Product Change Notice (PCN)

PCN Number: PCN-0454731R-01

Product(s) Affected: SJ-2504A-SMT-TR

PREVIOUS CUI DEVICES DETAIL / IMAGE	NEW CUI DEVICES DETAIL / IMAGE

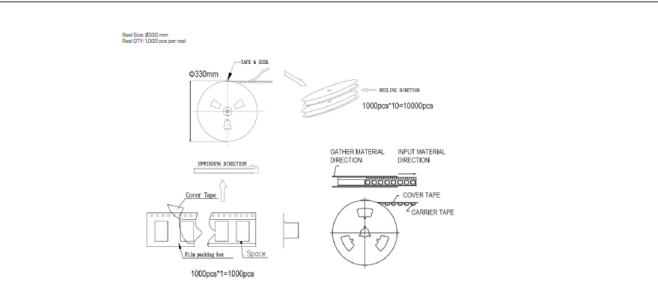
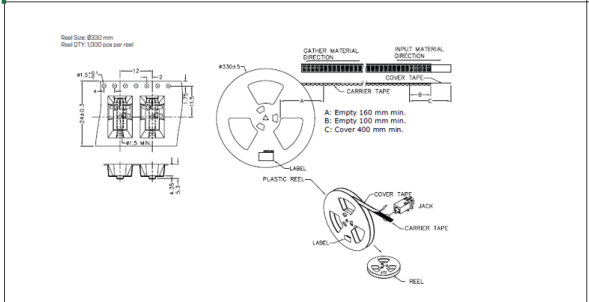
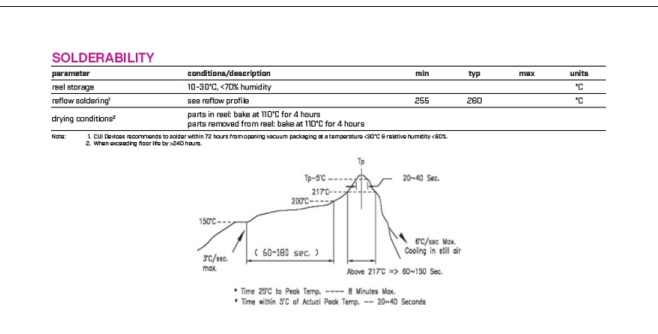
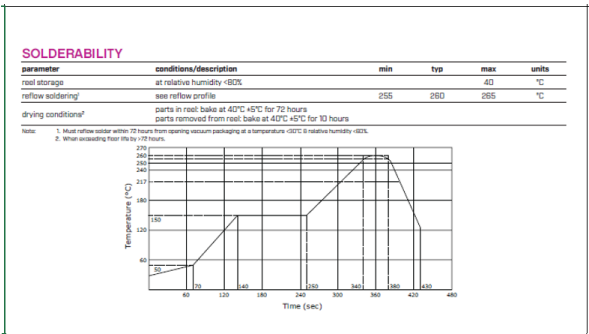
Description of Change: mechanical, material, packaging, and soldering differences as shown below:

<p style="text-align: center;">Recommended PCB Layout Top View</p>	 <p style="text-align: center;">Recommended PCB Layout Top View</p>																																				
<table border="1"> <thead> <tr> <th></th> <th>MATERIAL</th> <th>PLATING</th> </tr> </thead> <tbody> <tr> <td>terminal 1</td> <td>copper alloy</td> <td>silver</td> </tr> <tr> <td>terminal 2</td> <td>copper alloy</td> <td>silver</td> </tr> <tr> <td>terminal 3</td> <td>copper alloy</td> <td>silver</td> </tr> <tr> <td>terminal 4</td> <td>copper alloy</td> <td>silver</td> </tr> <tr> <td>plastic</td> <td>PA10T</td> <td></td> </tr> </tbody> </table>		MATERIAL	PLATING	terminal 1	copper alloy	silver	terminal 2	copper alloy	silver	terminal 3	copper alloy	silver	terminal 4	copper alloy	silver	plastic	PA10T		<table border="1"> <thead> <tr> <th>DESCRIPTION</th> <th>MATERIAL</th> <th>PLATING/COLOR</th> </tr> </thead> <tbody> <tr> <td>terminal 1</td> <td>phosphorus bronze</td> <td>silver</td> </tr> <tr> <td>terminal 2</td> <td>phosphorus bronze</td> <td>silver</td> </tr> <tr> <td>terminal 3</td> <td>phosphorus bronze</td> <td>silver</td> </tr> <tr> <td>terminal 4</td> <td>phosphorus bronze</td> <td>silver</td> </tr> <tr> <td>housing</td> <td>PPA [UL94V-0]</td> <td>black</td> </tr> </tbody> </table>	DESCRIPTION	MATERIAL	PLATING/COLOR	terminal 1	phosphorus bronze	silver	terminal 2	phosphorus bronze	silver	terminal 3	phosphorus bronze	silver	terminal 4	phosphorus bronze	silver	housing	PPA [UL94V-0]	black

MATERIAL	PLATING																																			
terminal 1	copper alloy	silver																																			
terminal 2	copper alloy	silver																																			
terminal 3	copper alloy	silver																																			
terminal 4	copper alloy	silver																																			
plastic	PA10T																																				
DESCRIPTION	MATERIAL	PLATING/COLOR																																			
terminal 1	phosphorus bronze	silver																																			
terminal 2	phosphorus bronze	silver																																			
terminal 3	phosphorus bronze	silver																																			
terminal 4	phosphorus bronze	silver																																			
housing	PPA [UL94V-0]	black
